# PATRIOT PLACE SUBDIVISION - A

A REPLAT OF LOTS 1 & 2, PATRIOT PLACE, LOCATED IN THE SOUTHWEST QUARTER OF SECTION 11, TOWNSHIP 11 SOUTH, RANGE 67 WEST OF THE 6TH P.M.,

SHEET 1 OF 2

# Final Plat Drawing\_V2.pdf Markup Summary

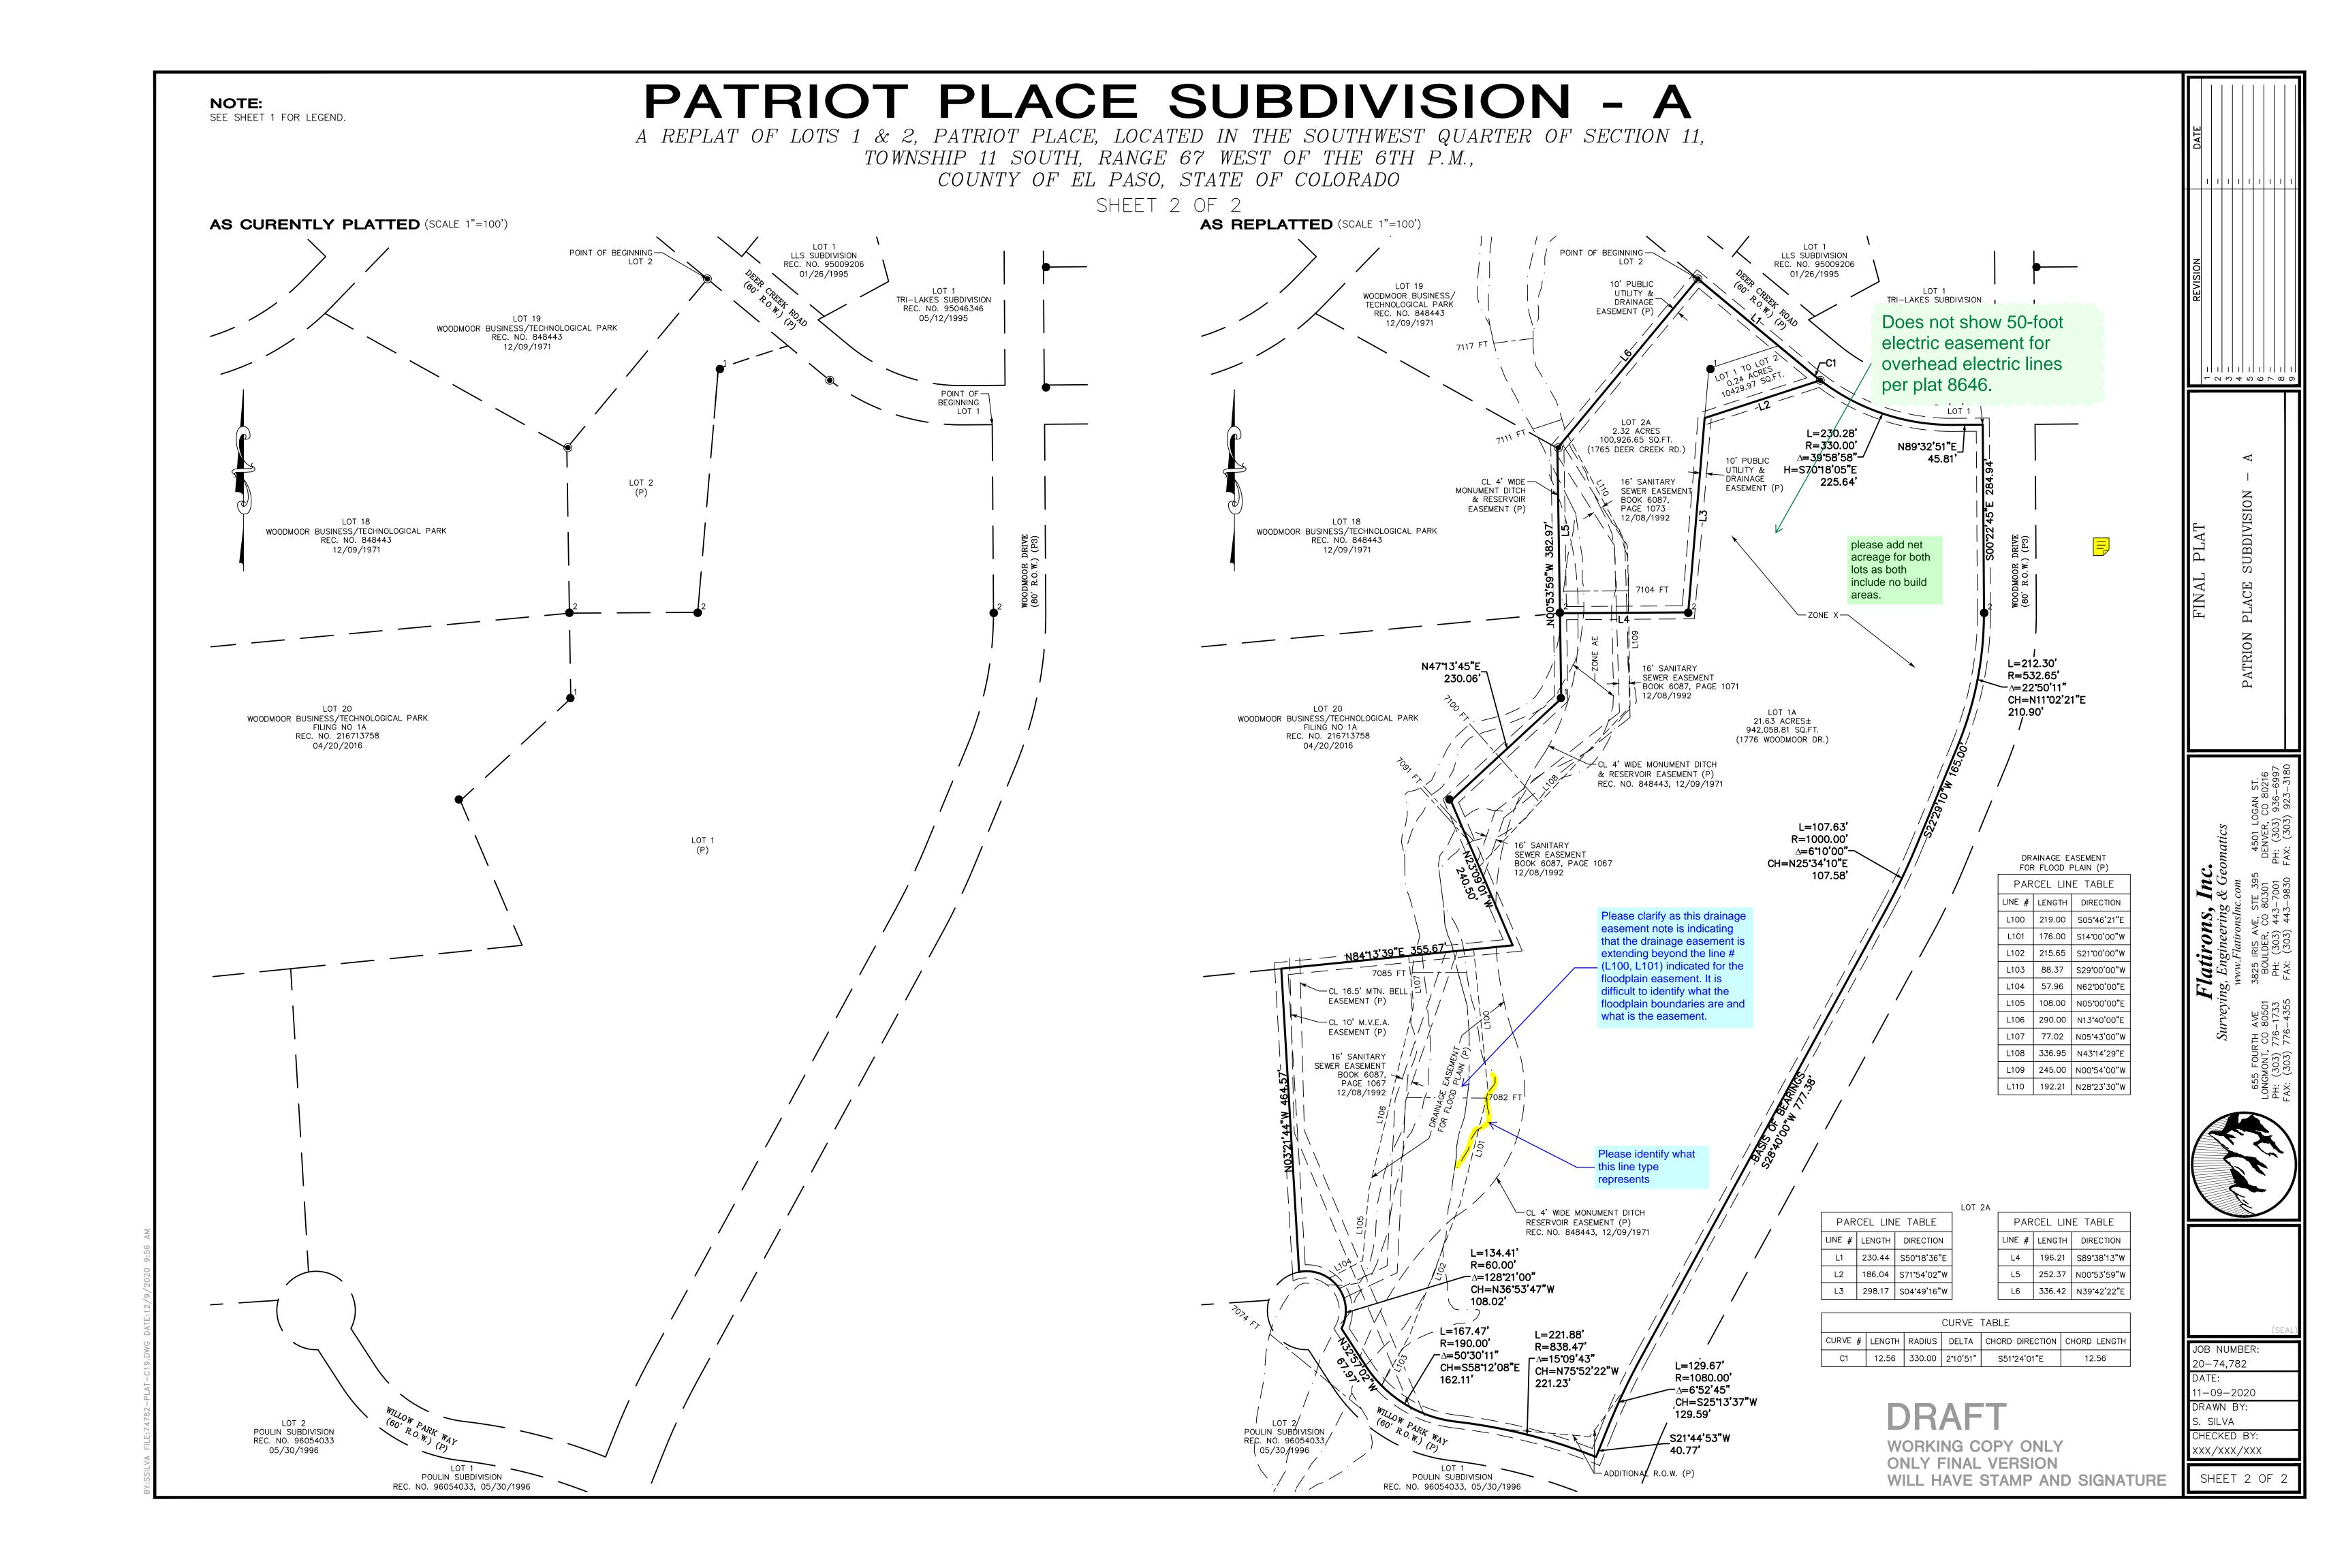
Status: Color: Layer: Space: Please identify what this line type represents

Status: Color: Layer: Space: Please clarify as this drainage easement note is indicating that the drainage easement is extending beyond the line # (L100, L101) indicated for the floodplain easement. It is difficult to identify what the floodplain boundaries are and what is the

Status: Color: Layer: Space: Does not show 50-foot electric easement for overhead electric lines per plat 8646.

Status: Color: Layer: Space: HI Sophie, I could be wrong on this but I saw a note on EDARP that says a 50' electric easement was removed. Just thought you should know just in case you didnt see it and it affects this comment.

please add net acreage for both lots as both include no build areas.
